**REQUEST FOR INFORMATION  
FOR**

RFI # **2**

**NAME :** VA Mare Island Outpatient Clinic  
**ADDRESS:** 201 Walnut Ave, Vallejo, CA 94592  
**JOB # :** SP-15-121

**TITLE OR DESCRIPTION :** Isolation Valve Locations

Project Number <b>612-14-035</b>
Building Number <b>201</b>
Drawing Number <b>H-101</b>

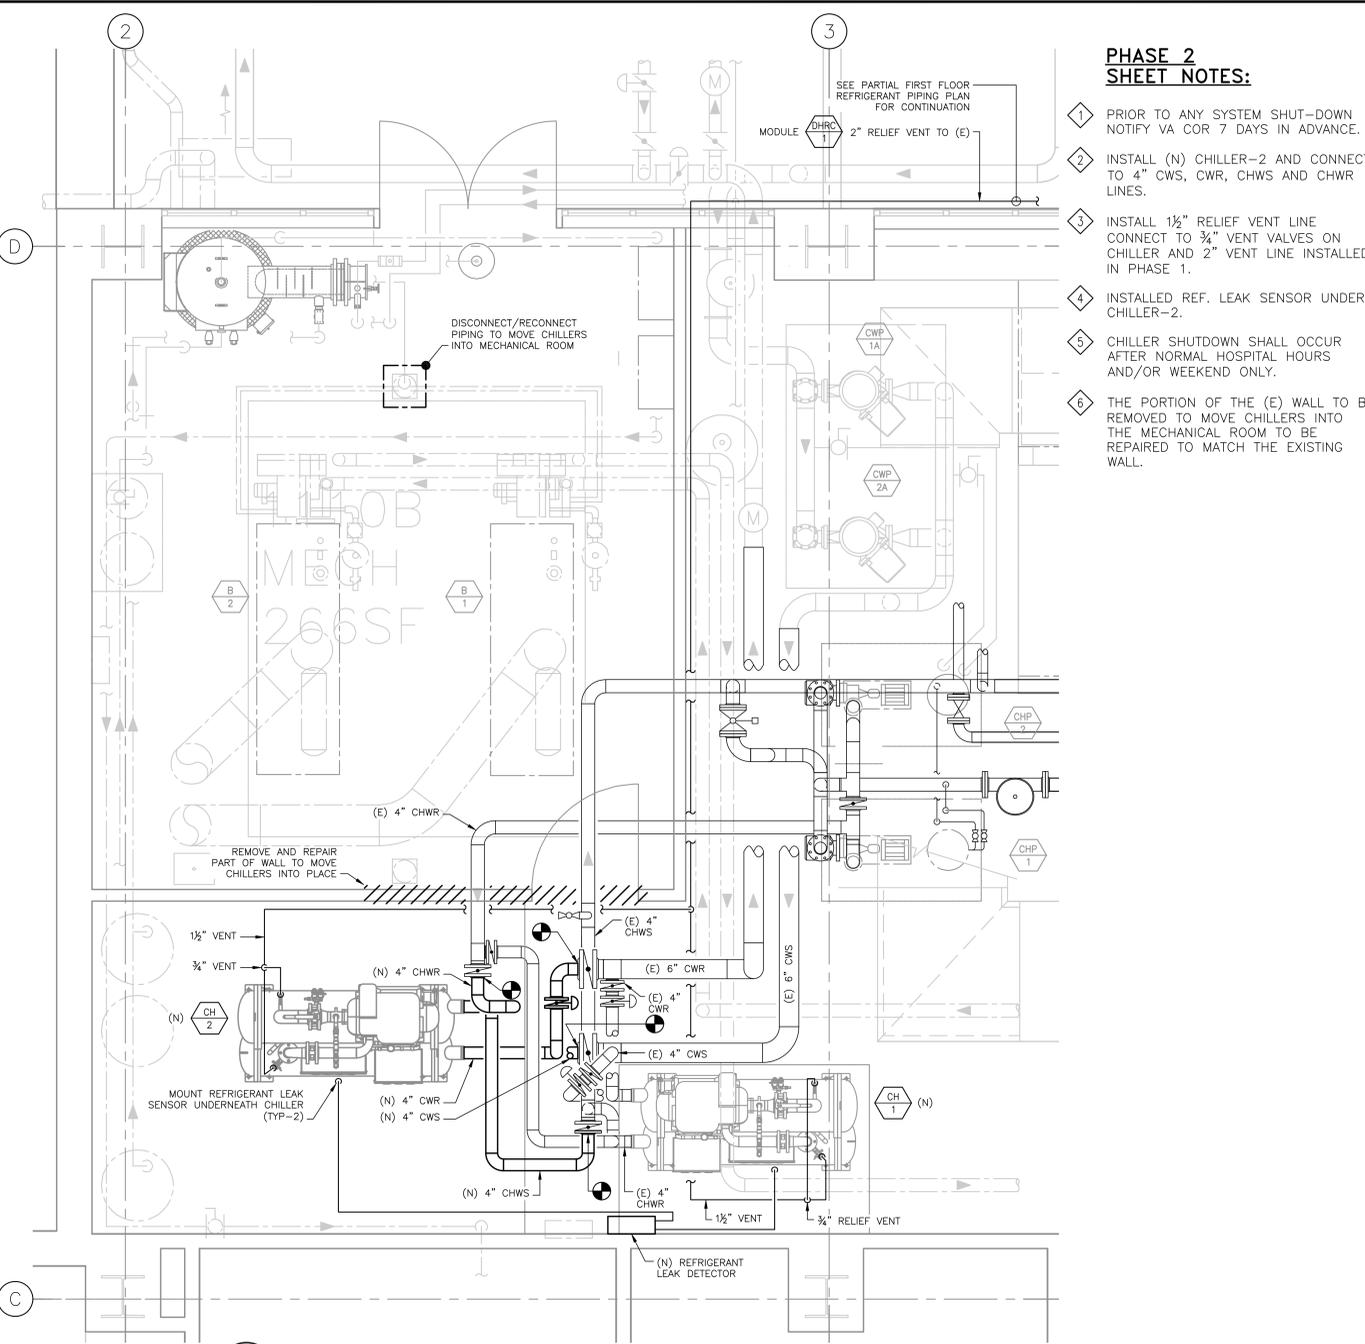
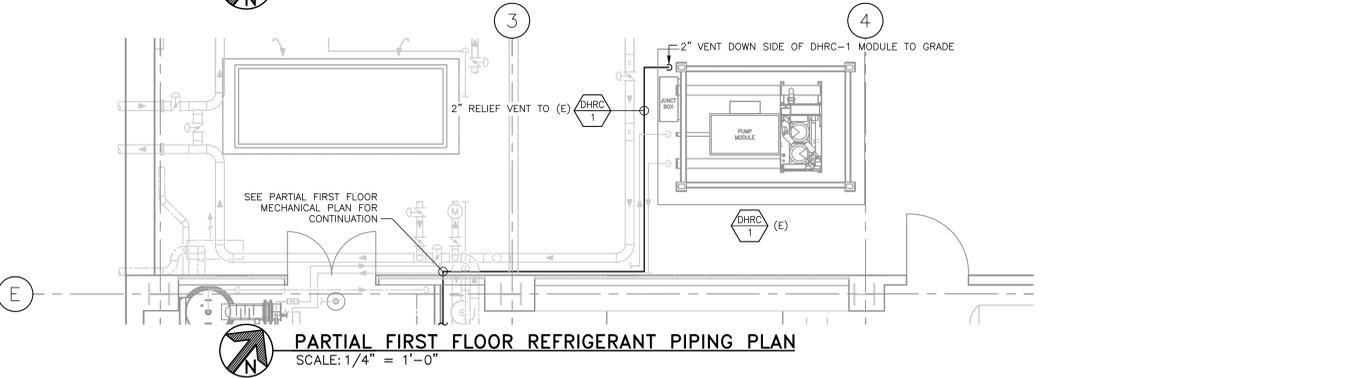
Please clarify where the isolation valves, if any, are located on the existing piping systems. Drawing sheet H-101 (attached) does not specify locations of any isolation valves which will be needed for installation of new piping.

Can the new area of construction be isolated from the existing portion of piping.

There are no current isolation valves on the existing system. New isolation to be installed during the shutdown. This will provide the necessary isolation for the old chiller to be used while the new chiller is installed.
